ADDENDUM NO: 01

PROJECT: Pendleton Elementary Roofing Replacement

PROJECT NO: 2026060

DATE: 07/24/26

DRAWING TITLE:
DEMOLITION
PLAN - ROOF

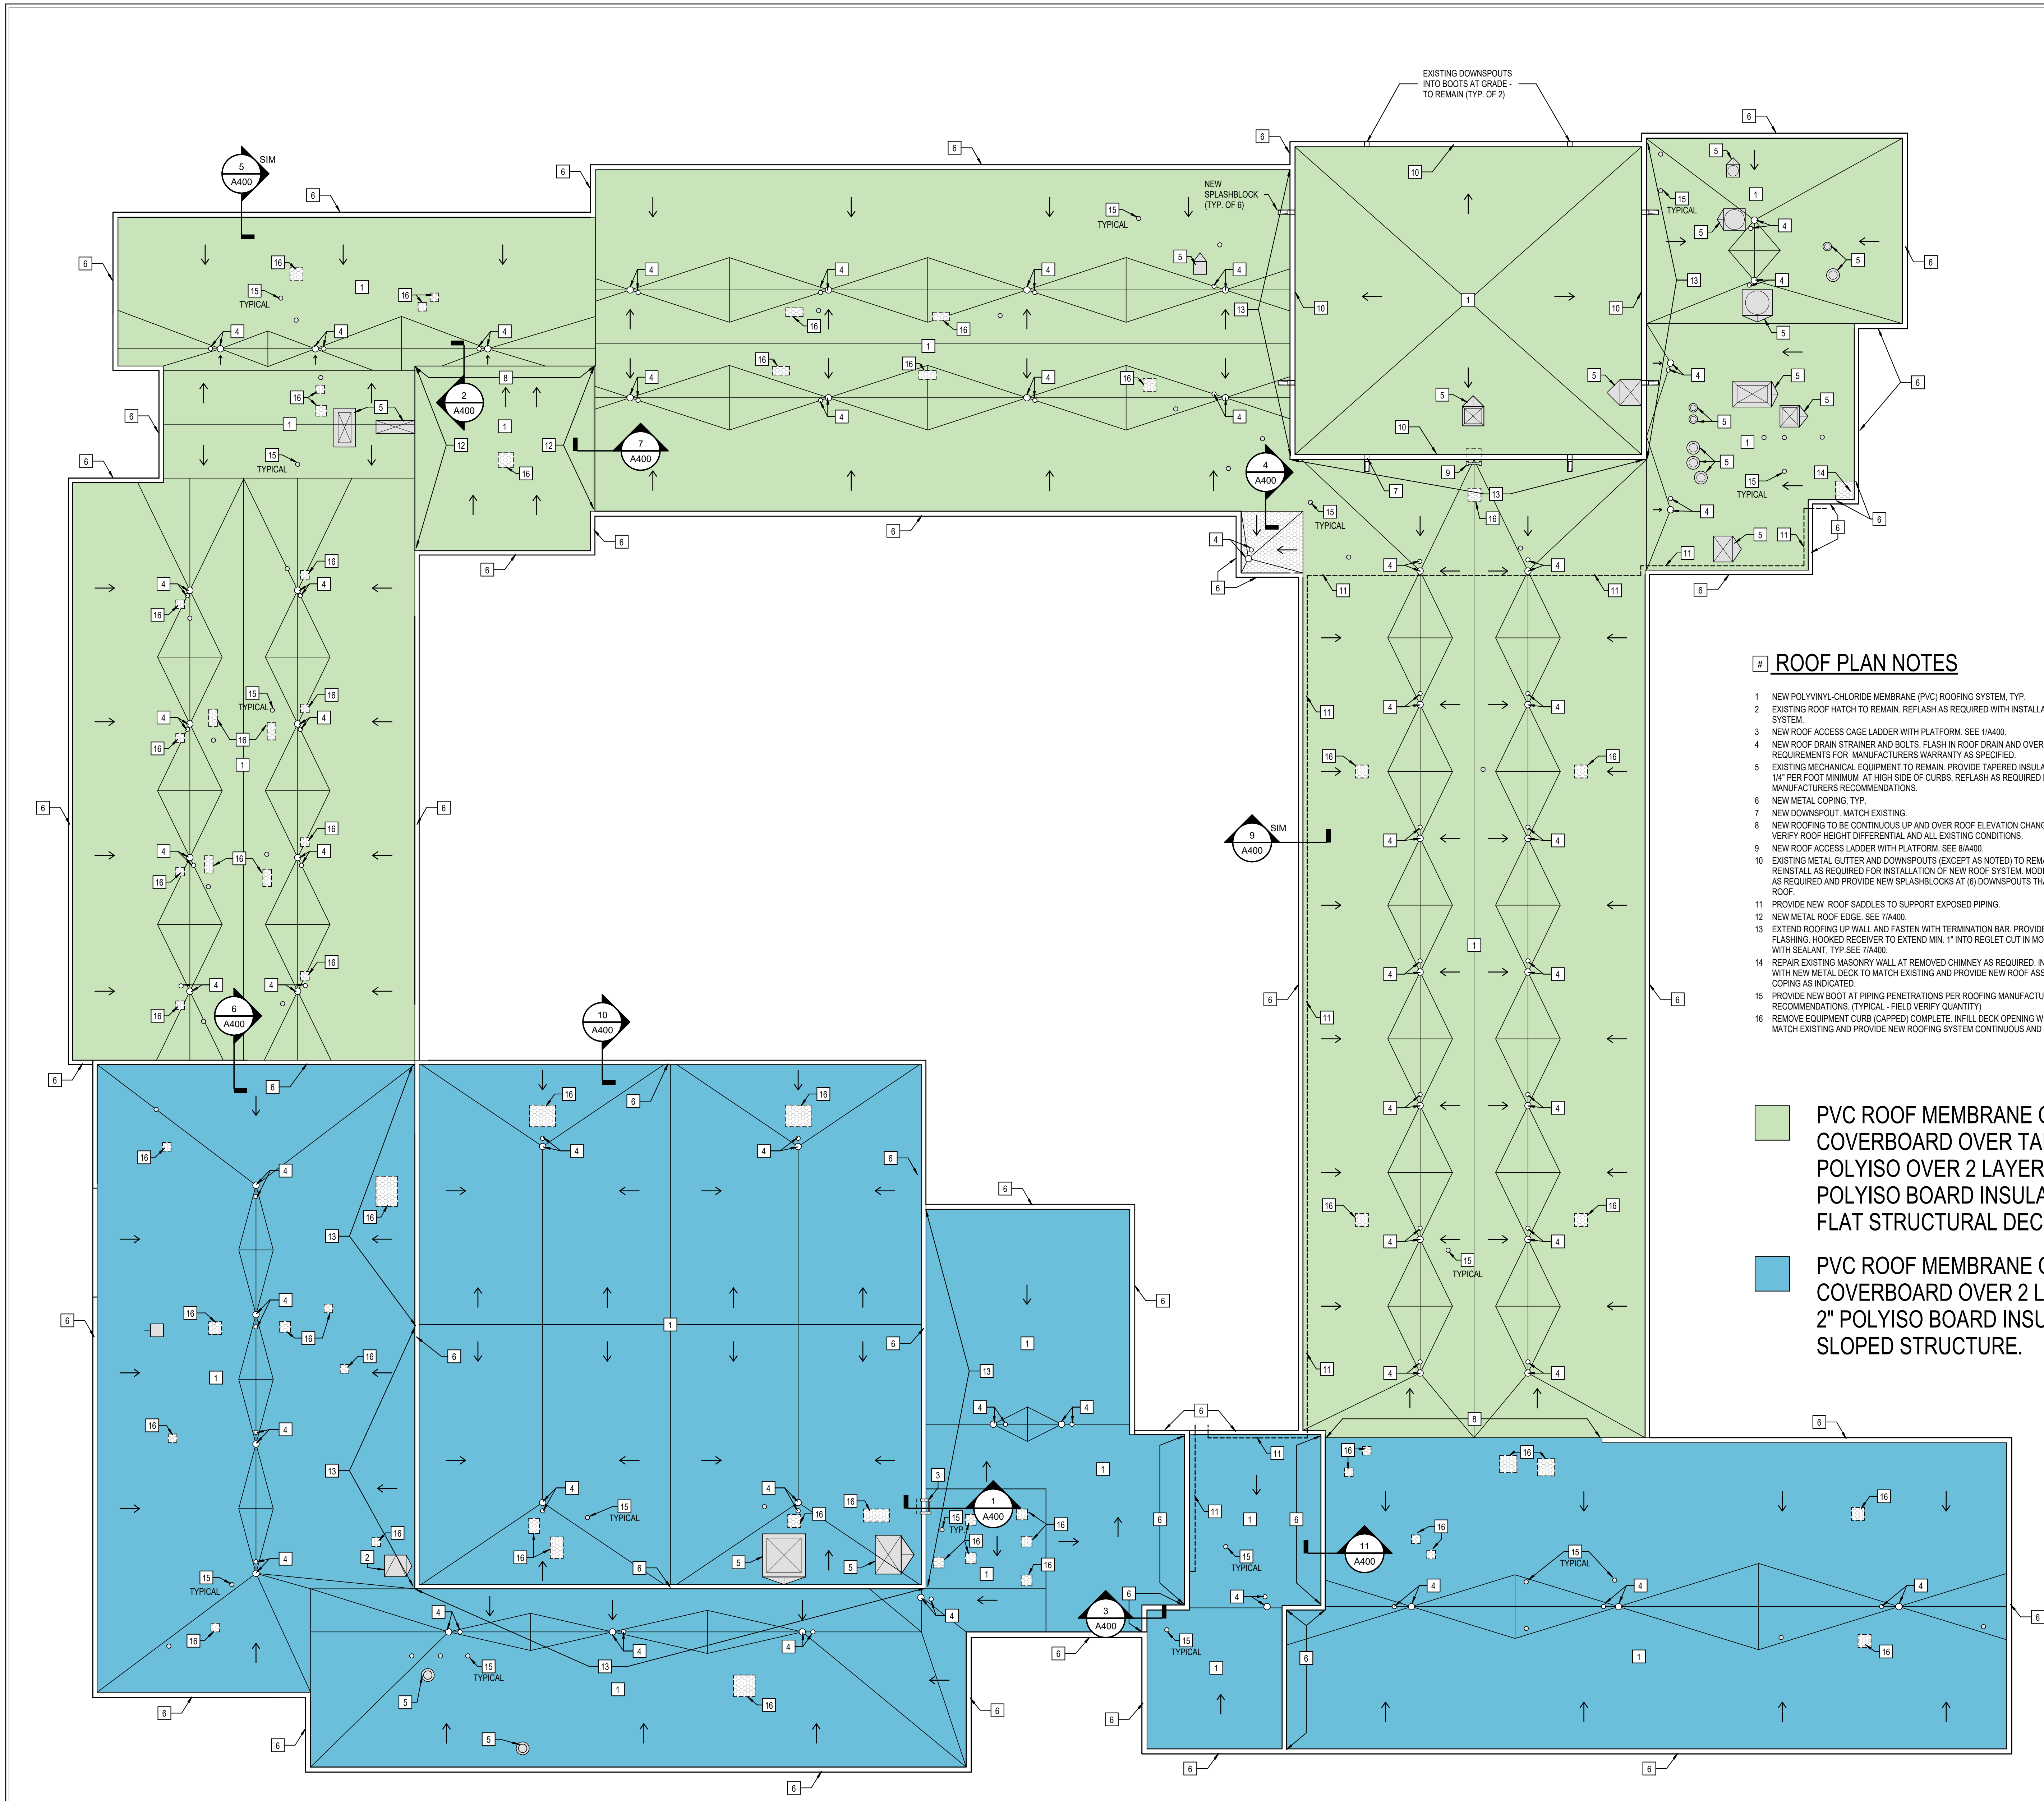
3.1 AD100 – DEMOLITION PLAN - ROOF

A. Add colored hatch & legend to reflect differing existing structural and roof conditions

1. Light green to represent existing EPDM roof system on flat gypsum roof deck.
2. Dark green to represent existing EPDM roof system on flat steel roof deck.
3. Light blue to represent existing TPO roof system on metal deck over sloped structure.
4. Dark blue to represent existing EPDM roof system on metal deck over sloped structure.
5. Purple to represent existing EPDM roof system on Tectum deck over sloped structure.
